**Fraser Planning Commission Agenda
City Council Chambers
33000 Garfield, Fraser, MI 48026
Monday, January 13, 2025 @ 7:00 p.m.**

Site Plan Review Summary

Site Plan Dated 12/19/2024
City of Fraser, Michigan

SITE ADDRESS / LOCATION 34625 & 34835 Utica Road- 03-11-31-202-002 & 03-11-31-100-049	APPROVING BODY Planning Commission	PUBLIC HEARING DATE N/A
STAFF REPORT CONTACT INFORMATION Building Clerk – Kayshe Johnson– (586) 293-3100 ext. 154 Planning Consultant – Lauren Sayre, AICP – (586) 293-3100 ext. 153	APPLICANT / PROPERTY OWNER Mister Car Wash, Applicant Good Will Co. Inc., Property Owner

MISTER CAR WASH
STORE # MI 1454 FRASER
SITE PLANS
LAYOUT PLAN

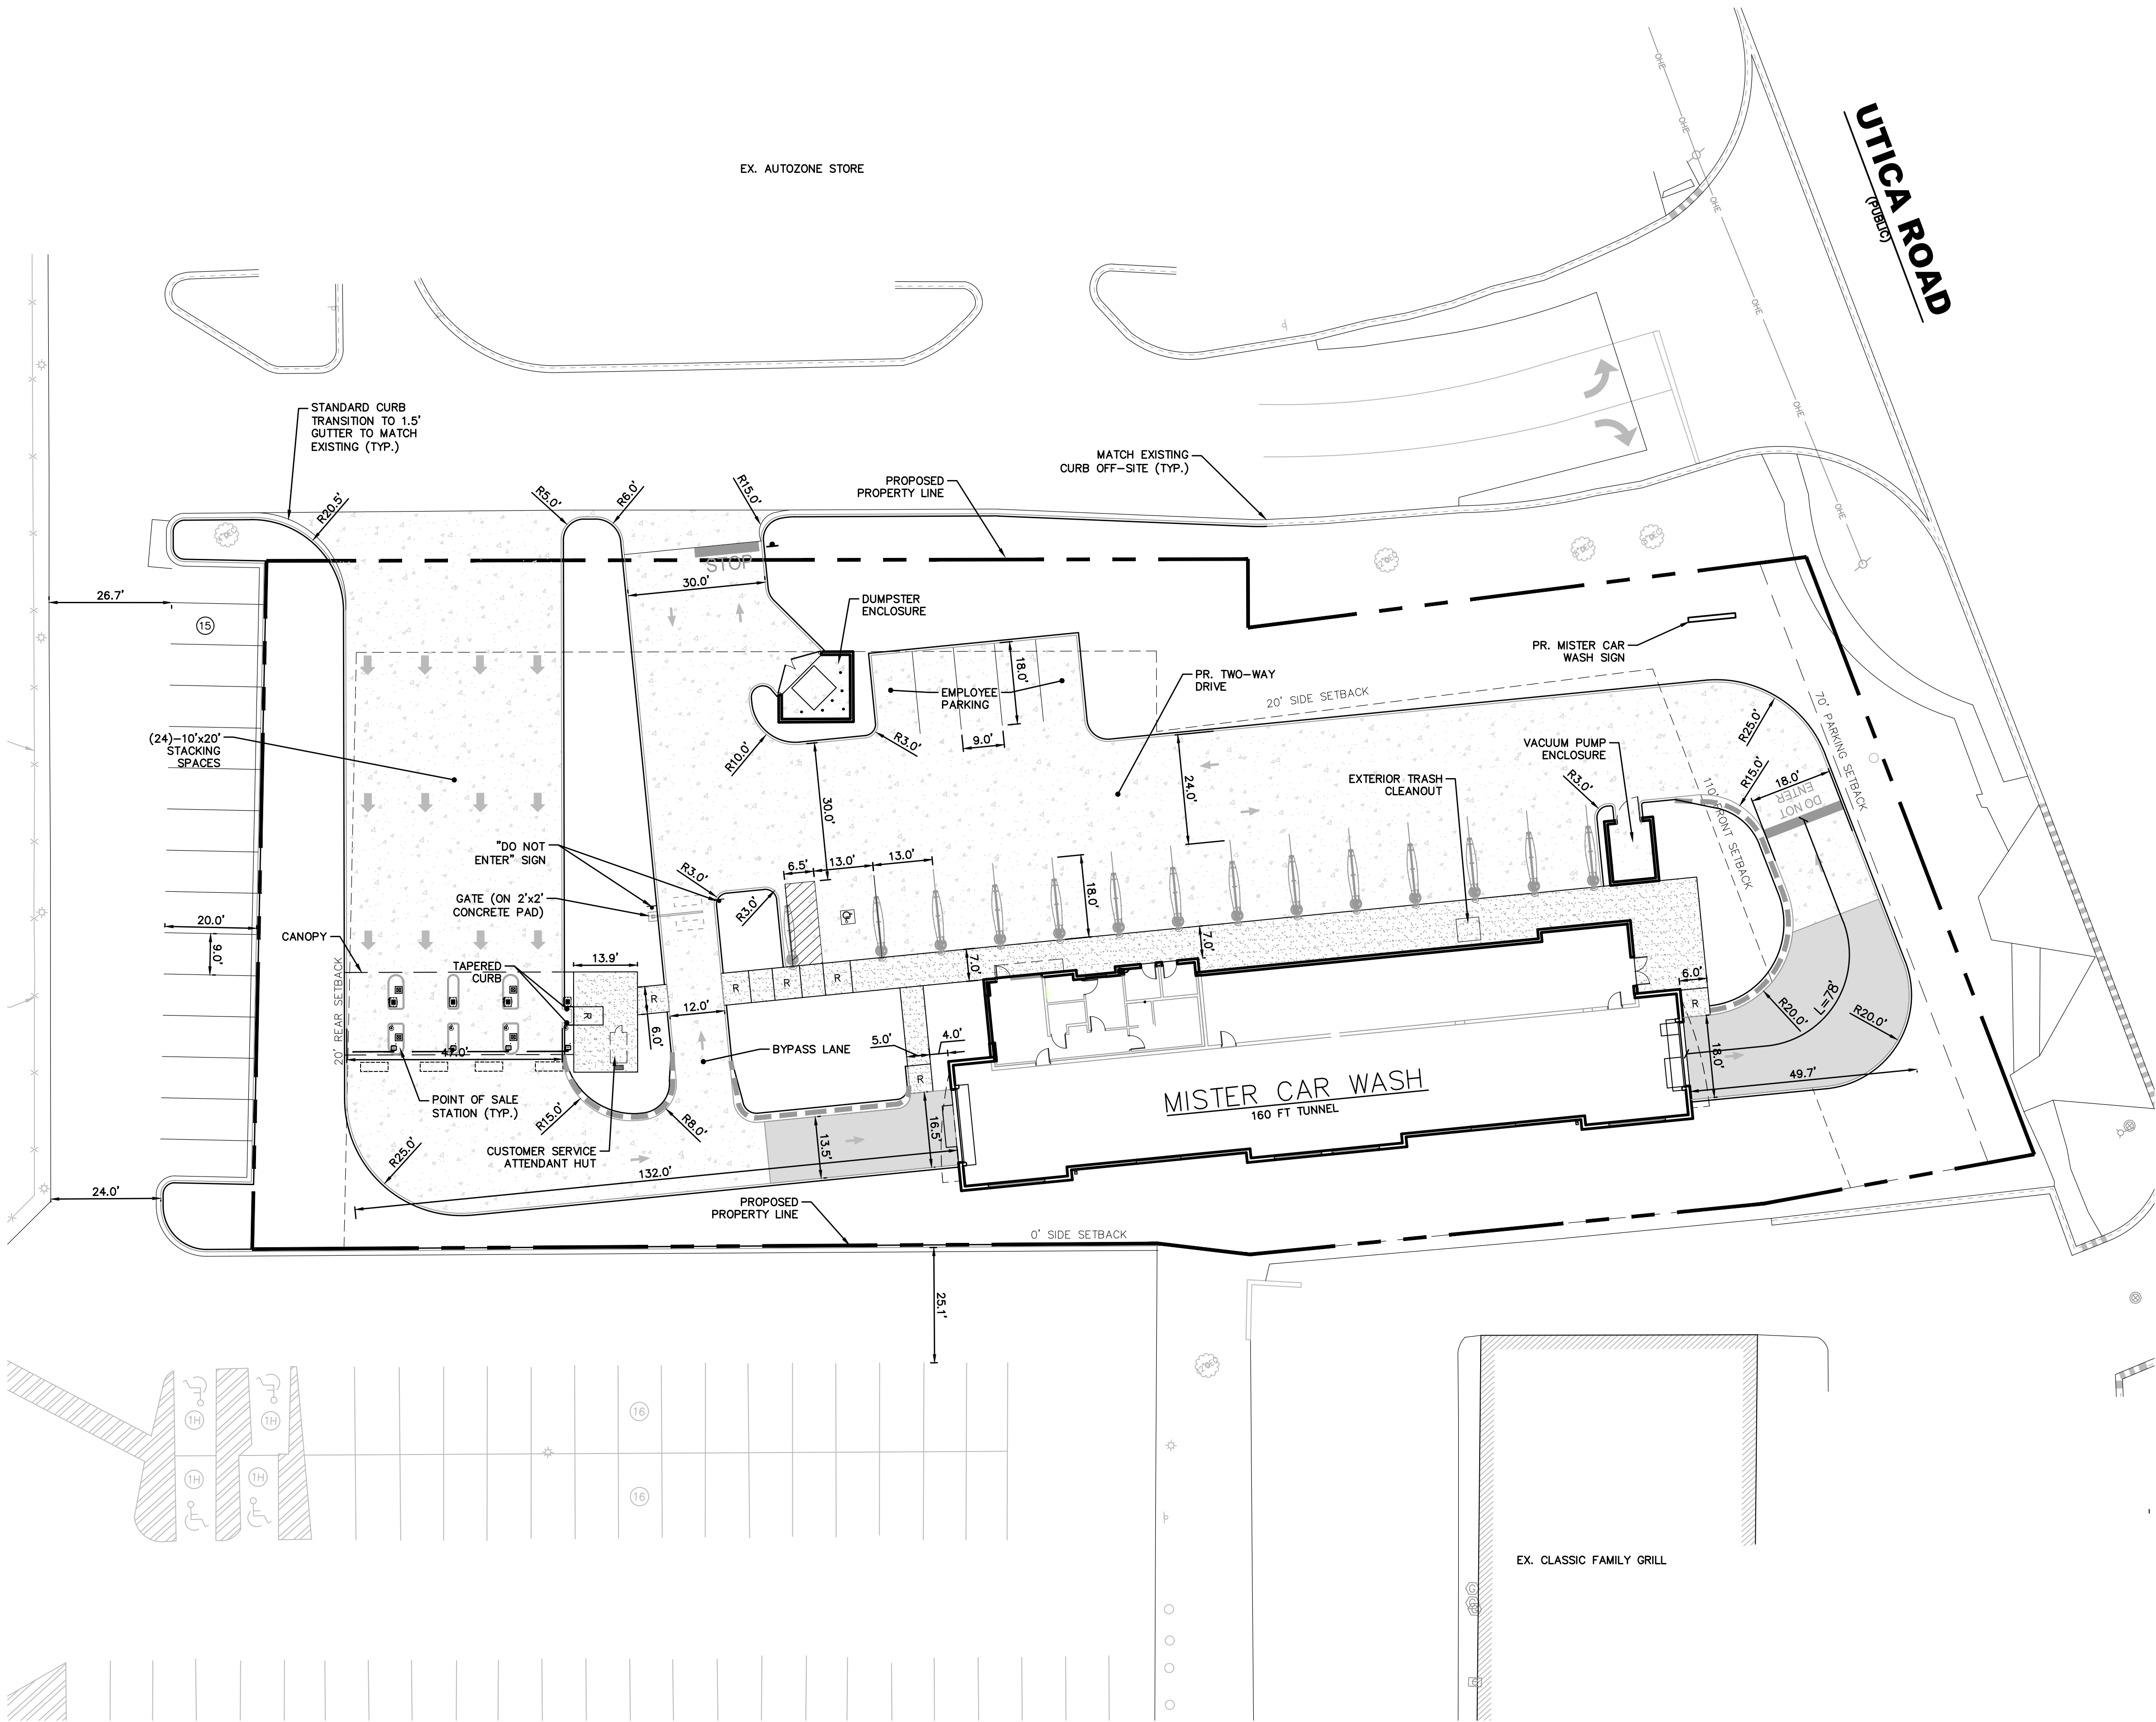
The applicant is seeking to amend their site plan to change the south, side lot boundary. The amended boundary would eliminate the need for a cross-access agreement and would be consistent with the site plan amendment and variance that Meijer received for their parking reduction.

The site plan indicates 9x18 foot stalls for employees, and 13x18 foot stalls for the vacuum parking stalls, with a 24-foot maneuvering lane. However, Sec 32-94(8) specifies that in any area where front-end parking abuts a curbed landscaped area or a raised sidewalk having a minimum width of at least seven (7) feet, the minimum parking stall depth of twenty (20) feet (as otherwise specified herein) may be decreased by up to two (2) feet in depth in order to allow for a vehicle to overhang such landscaped area or such sidewalk. In no case shall the parking stall depth be decreased to allow a vehicle to overhang a required parking setback or property line.

The proposed plan shows one point of ingress that is 47 feet wide. The second point of ingress and egress (east driveway) is 30 feet wide. This item is compliant.

OFFICE ELEVATION - NORTH
SCALE: 1/8" = 1'-0"

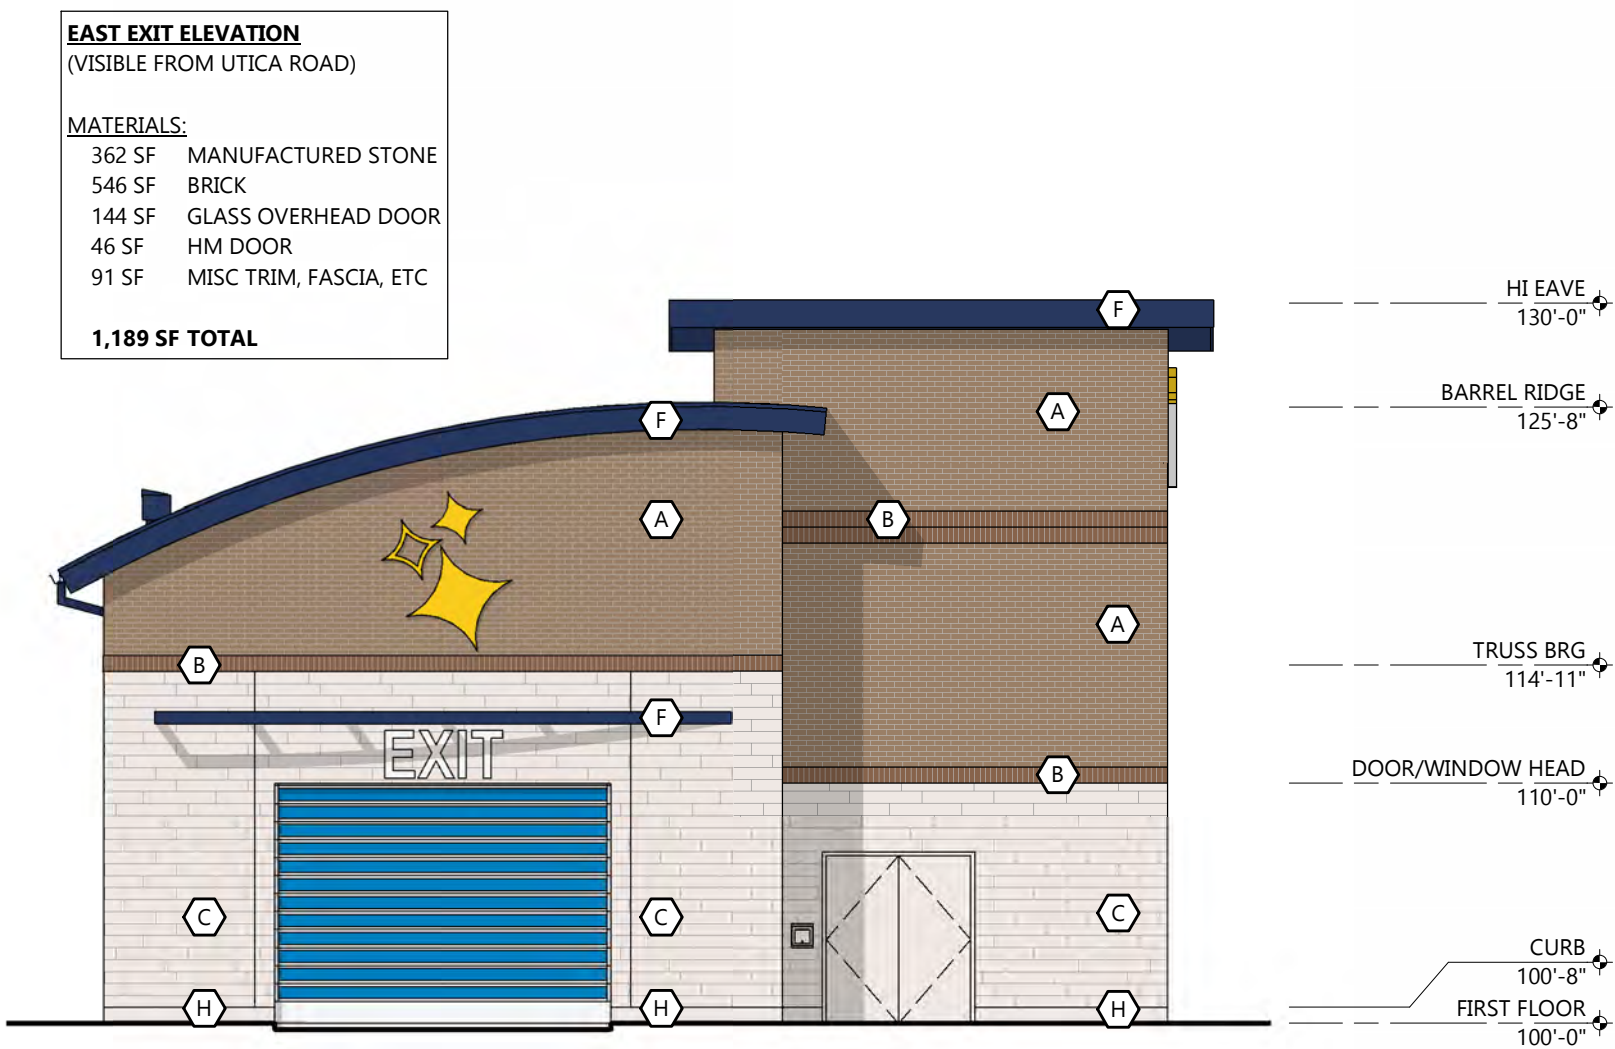
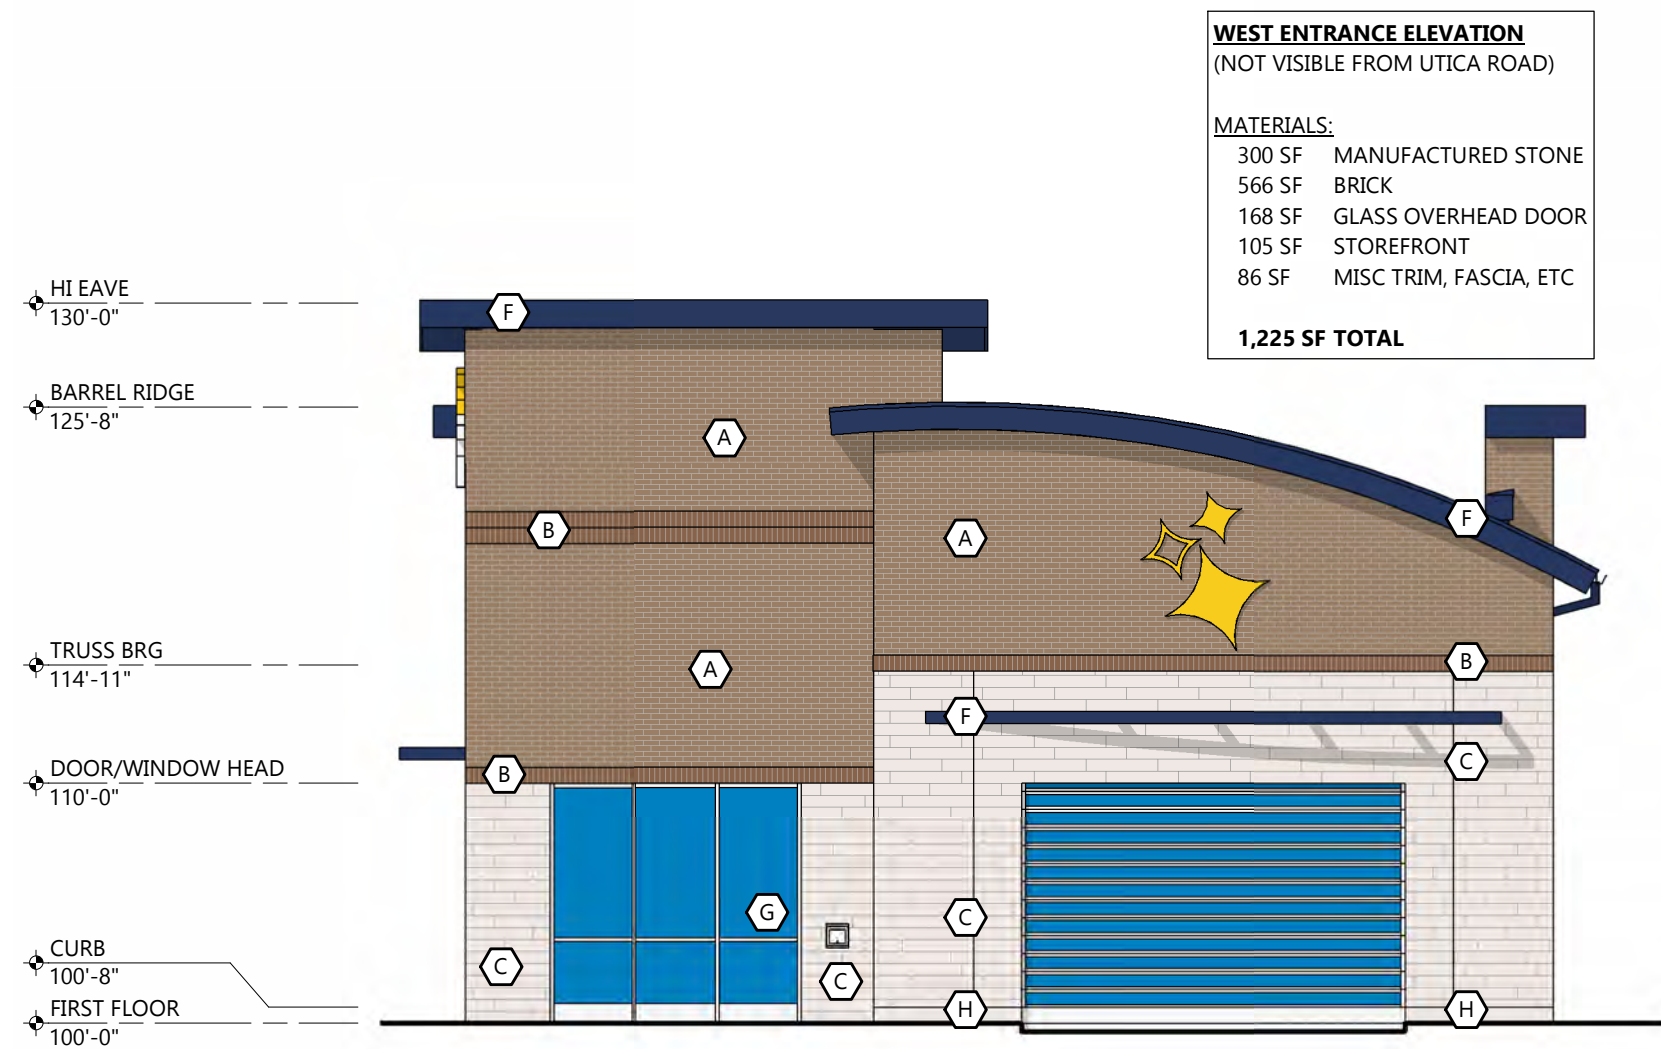
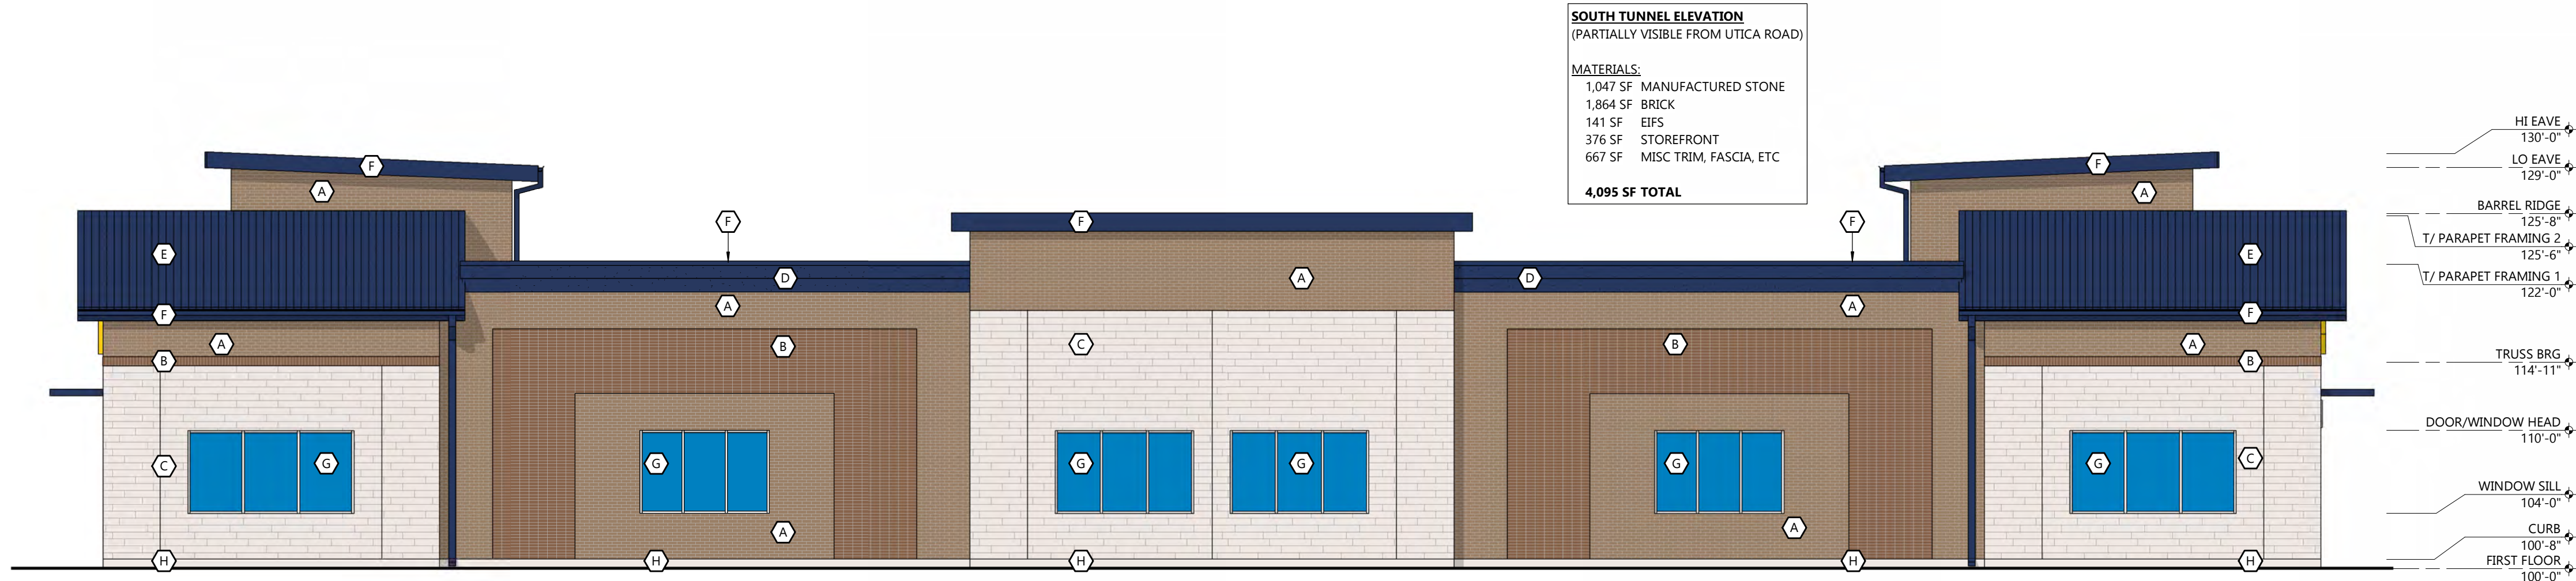
He reviewed the elevations of the building indicating they used brick and stone and high quality material on this building. He referred to a comment made by the Planner regarding the use of EIFS. He noted that there was about 300 square feet of EIFS used on this building or 2.8% of the building would be this material.

The building elevations provided by the applicant show that the exterior of the building will be composed of brick veneer, stone and EIFS, with accents of aluminum panels.

Per Sec. 32-131, *“Other durable, decorative building materials may be approved by the planning commission in instances where the character and style of the proposed structure warrants special consideration.”* The Planning Commission approved the EFIS portions of the building on December 4, 2024.
